## Landscape Referral Response

<b>Application Number:</b>	DA2018/1514
<b>Date:</b>	23/11/2018
<b>Responsible Officer:</b>	Luke Perry
<b>Land to be developed (Address):</b>	Lot 100 DP 1015283 , 145 Old Pittwater Road BROOKVALE NSW 2100

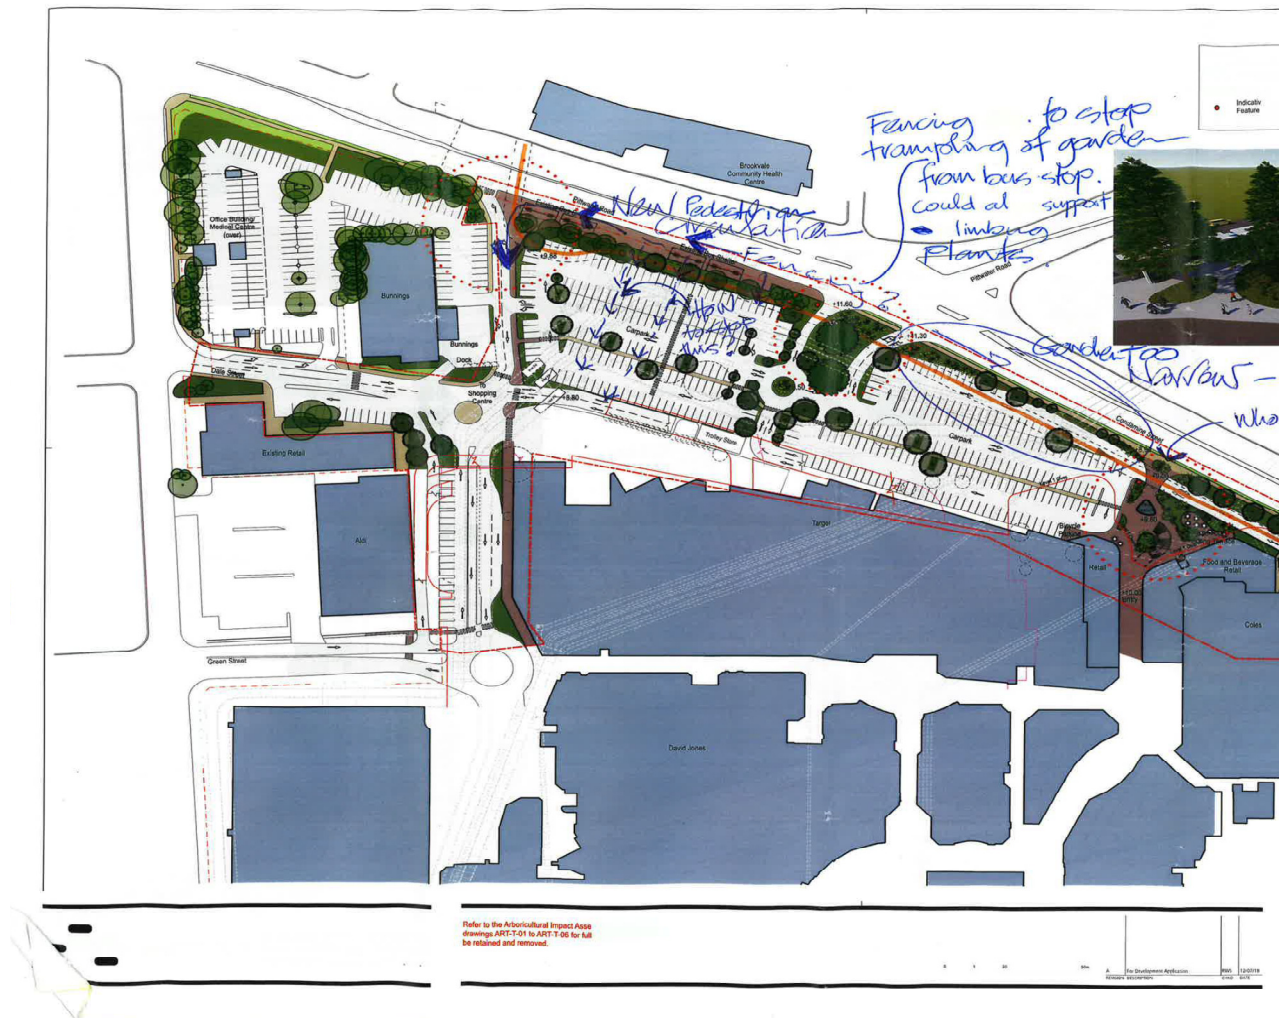
- Landscape area forward of the car-park opposite Warringah Golf Club:

The plans indicate reduction in the width of the landscape area with minimal landscape buffer to the carpark. The resultant area will be dominated by hard surfaces and cars. This is considered to be a poor response to the streetscape along a major arterial road. Insufficient width is provided to enable suitable planting to screen the car-park and integrate the bulk and scale of the development into the streetscape.
